SERVICE BULLETIN

Reference number:	SB-30-1571	Issued: 01 December, 2021
Subject:	Install Nitto Foam Pads to Bonnet	
Applicable to:	All Dealers	
Model:	DB11	
Distribute to:	After Sales Manager Executive Manager Service Manager Sales Manager	Warranty Staff Technician(s) Parts Staff

Figure 1

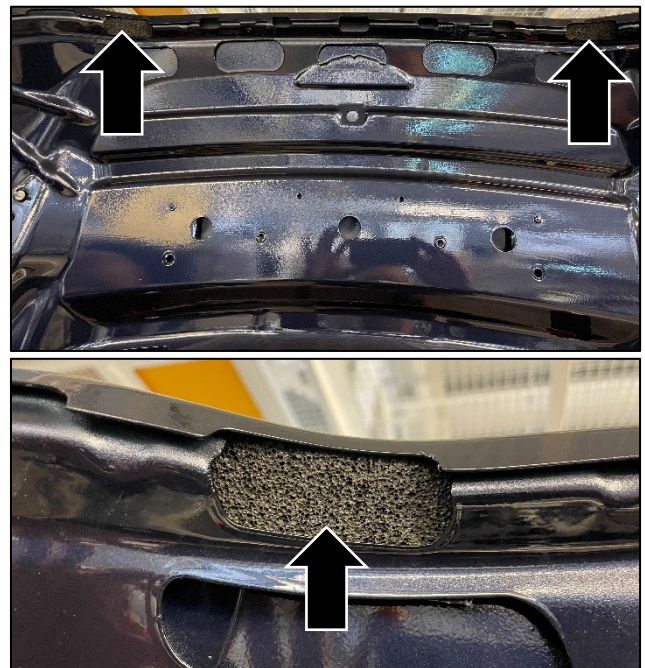
Aston Martin has found that some vehicles can have false triggers from the Park Distance Control (PDC) system. This is because interference can occur from the inner edge of the bonnet.

1. Open the bonnet.
2. Install the foam pads to the underside of the bonnet in the areas shown (refer to Figure 1).
